# Approach Permit & 911 Address Form

Permit #: 67-09-18

<b>Applicant/ Property Owner:</b> Glen Ullin Energy Center, LLC		<b>Current Mailing Address:</b> 30 W Superior St, Duluth, MN 55802			
<b>E-mail Address:</b> jhollingsworth@allete.com		<b>Daytime Phone or Cell #:</b> 218-355-3249			
<b>Lot:</b>	<b>Block:</b>	<b>Subdivision: Approach #5 Coordinates:</b> 46.977543, -101.844380	<b>Quarter:</b> NE 1/4	<b>Section:</b> 1	<b>Twp:</b> 140
				<b>Rge:</b> 89

APPROACH - 20' WIDE TOP MINIMUM

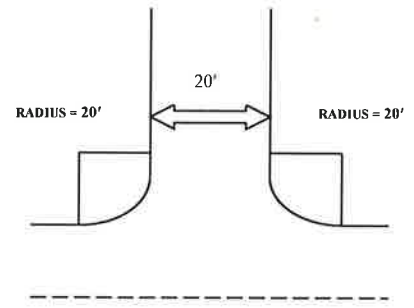
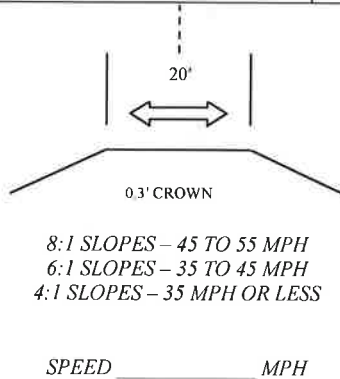
Culvert Comments: *At time of construction place a minimum of 1 foot fill over pipe and increase culvert length to correspond with desired approach top over 20 feet.*

Approach Comments: (Sight Distance? Problems? Etc.) *At time of construction place 4 inches gravel on approach.*
